UNITED STATES PATENT AND TRADEMARK OFFICE

APPLICATION NO.	FILING DATE	FIRST NAMED INVENTOR	ATTORNEY DOCKET NO.	CONFIRMATION NO.
09/992,092	11/05/2001	James H. Bucksbee	IR-2860(MT)	9463

Office Action Summary

DETAILED ACTION

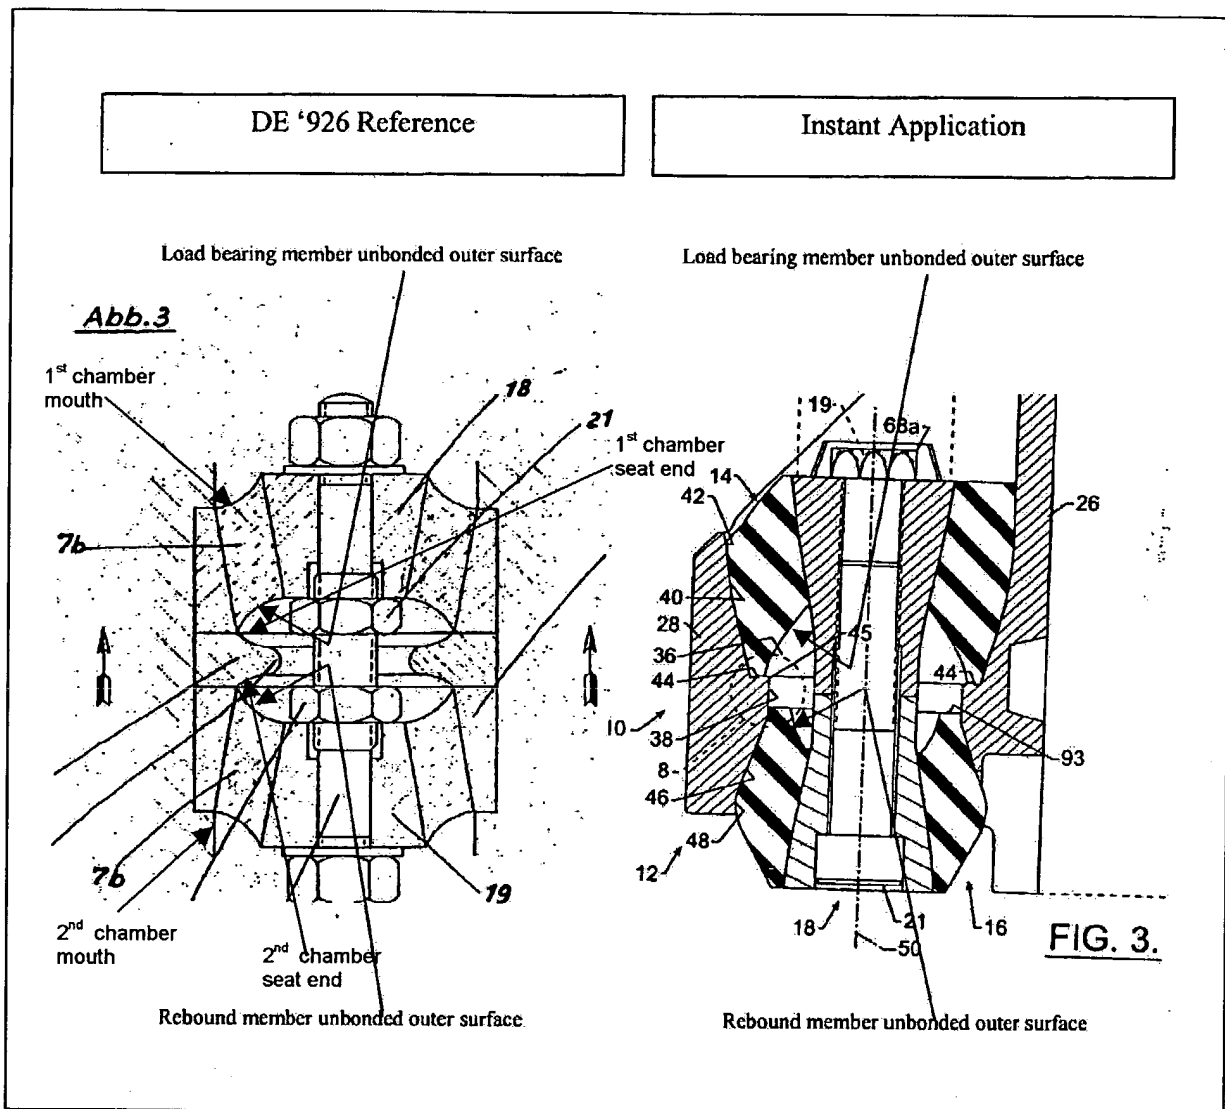
Re: claims 1, 4, 6, 11, 12, 15, 17, 22, 23, 25, and 26. DE '926 shows in figure 3 a mount comprising a rigid housing, the housing having a hollow barrel with a central axis and a first end and an opposing second end, the hollow barrel shown in the area of element 17 defining a first chamber in which upper element 7b is located proximate the

Re: claim 24. DE '926 shows in figure 3 the limitation wherein the load bearing member comprises a plurality of alignment members or nut and washer shown above element 18 along the support surface.

Re: claim 21. DE '926 show in figure 3 the limitation wherein the mount further comprises a plurality of arms or left and right projections shown in the area of element 24, the arms extend between the mount base and the barrel as shown.

Applicant argues that the unbonded outer surfaces of DE '926 are outwardly tapered in the direction of the mouth to the seat end. Examiner disagrees. As shown in figure 3 of the DE '926 reference labeled above the load bearing member outer resilient member unbonded outer surface is axially inwardly tapered in a direction from the first chamber mouth to the first chamber seat end. Similarly, the rebound member outer resilient member unbonded outer surface is axially inwardly tapered in a direction from the

second chamber mouth to the second chamber seat. Applicant also argues that unbonded outer surfaces of DE '926 are not seated against the wall of the outer metal housing elements 17. Examiner disagrees. It is noted that the radially outer corners of the unbonded outer surfaces are seated against the wall of the outer metal housing elements 17. Accordingly, the rejections have been maintained.
